Millstone Nuclear Power Station, Unit No. 3

Proposed Revision to Technical Specifications  
Shutdown Margin, Reactor Trip System, and  
Heat Flux Hot Channel Factor  
Retyped Up Pages

July 1994

FIGURE 3.1-5

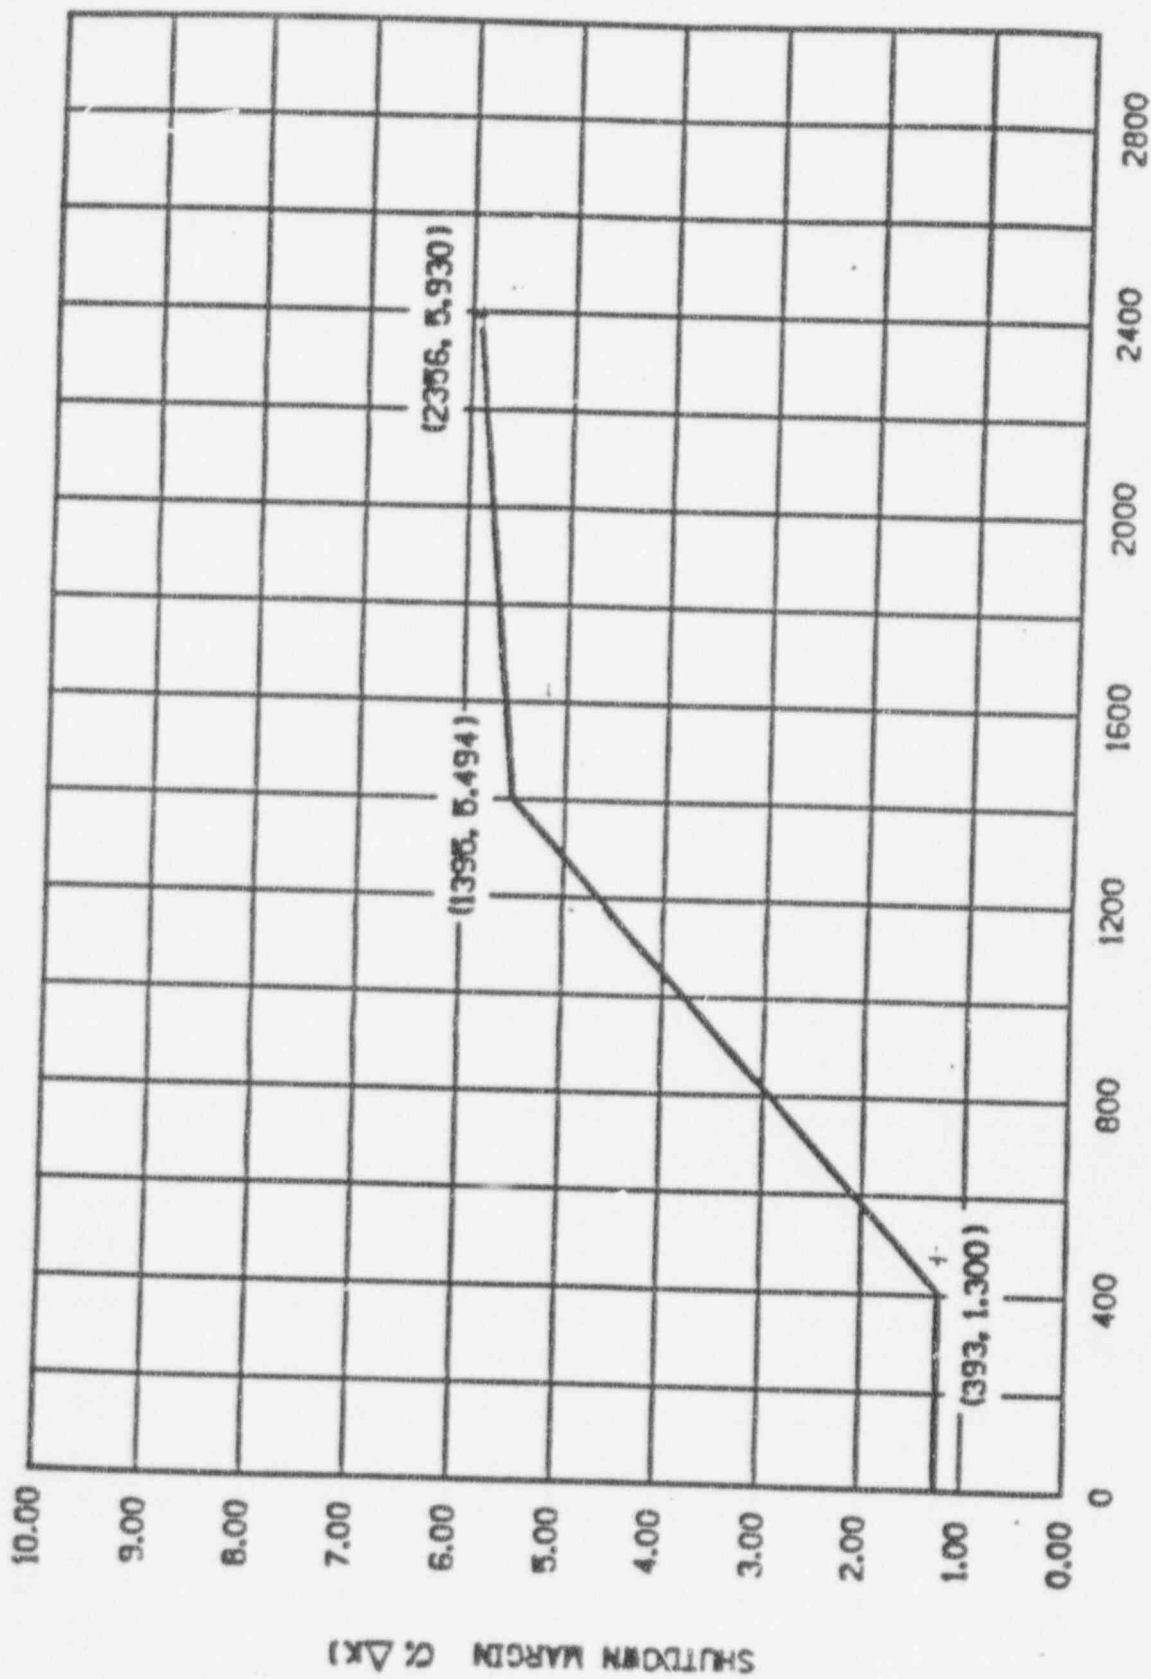
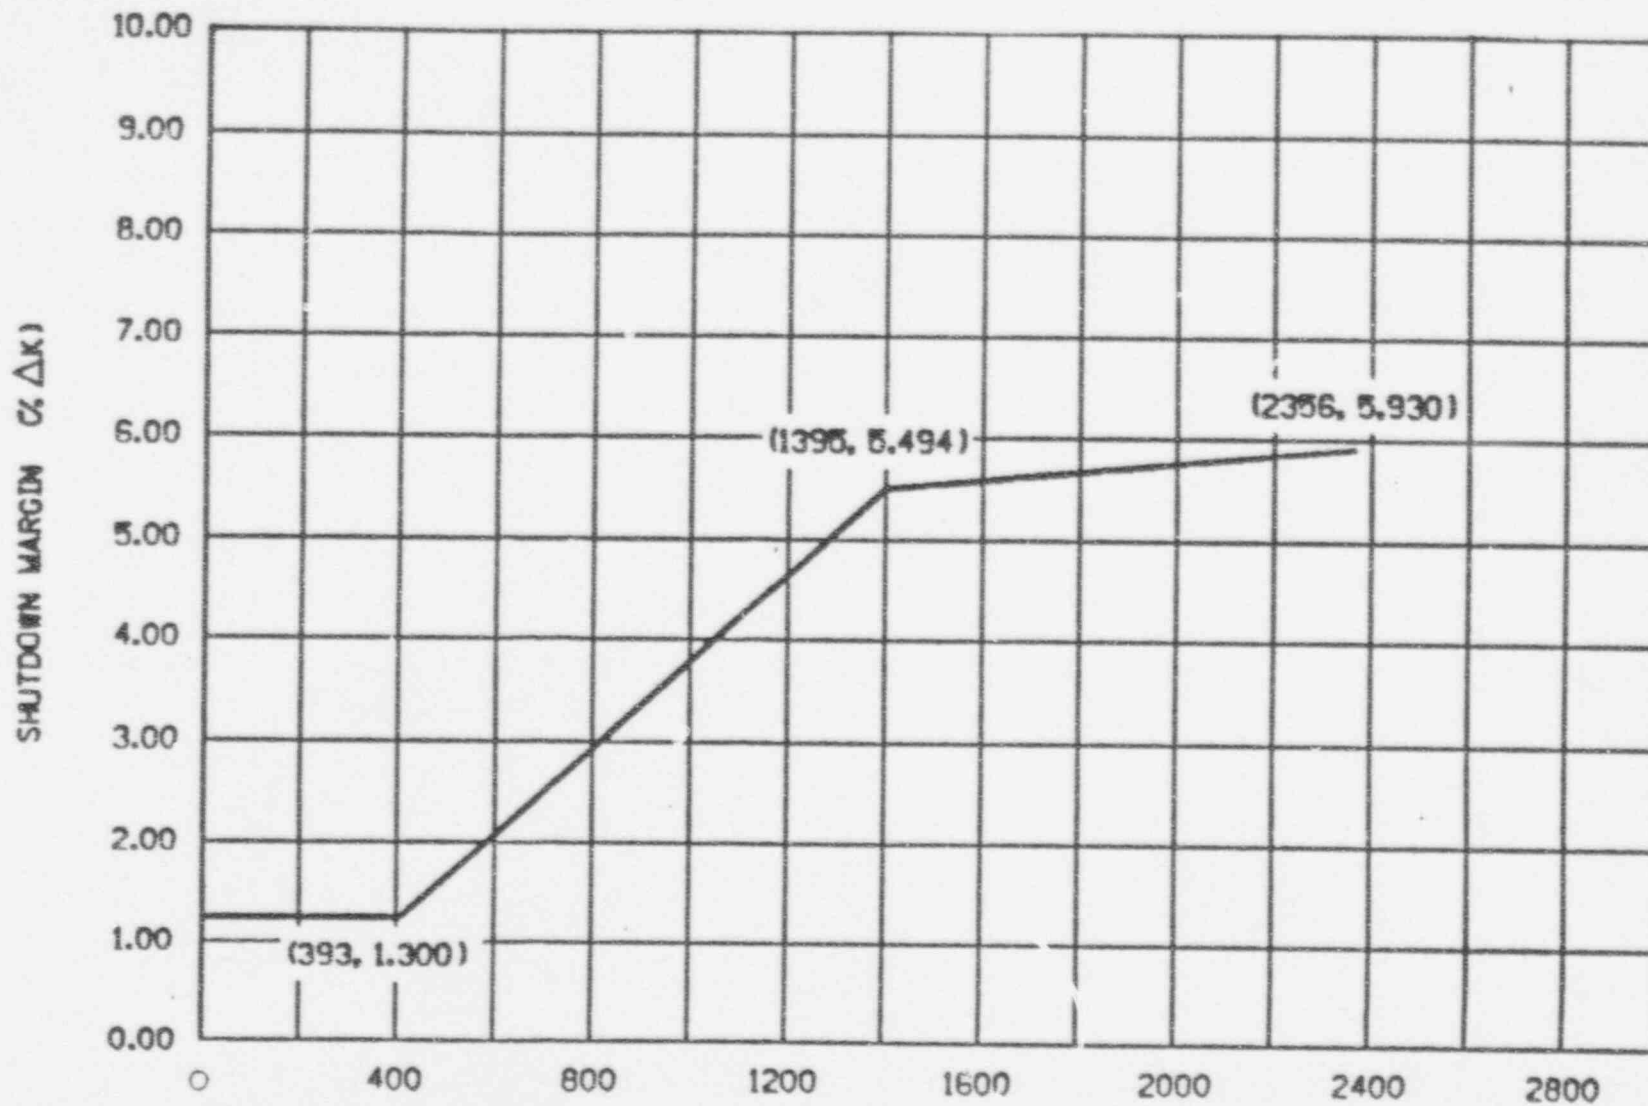
- a) the limits shown in Figure 3.1-5 or
- b) the limits shown in Figure 3.1-4 and secure the valves shown in Specification 4.4.1.4.2.3.

- b. With the CVCS dilution flow paths not closed and secured in position in accordance with Specification 3.1.1.2(b), immediately close and secure the paths or meet the limits shown in Figure 3.1-5

REQUIRED SHUTDOWN MARGIN FOR MODE 5 WITH RCS LOOPS DRAINED

NOT FILLED

- a) the limits shown in Figure 3.1-5 or
- b) the limits shown in Figure 3.1-4, with the chemical and volume control system (CVCS) aligned to preclude reactor coolant system boron concentration reduction.

RCS CRITICAL BORON CONCENTRATION (ppm)  
FIGURE 3.1-5  
REQUIRED SHUTDOWN MARGIN FOR MODE 5 WITH RCS LOOPS NOT FILLED
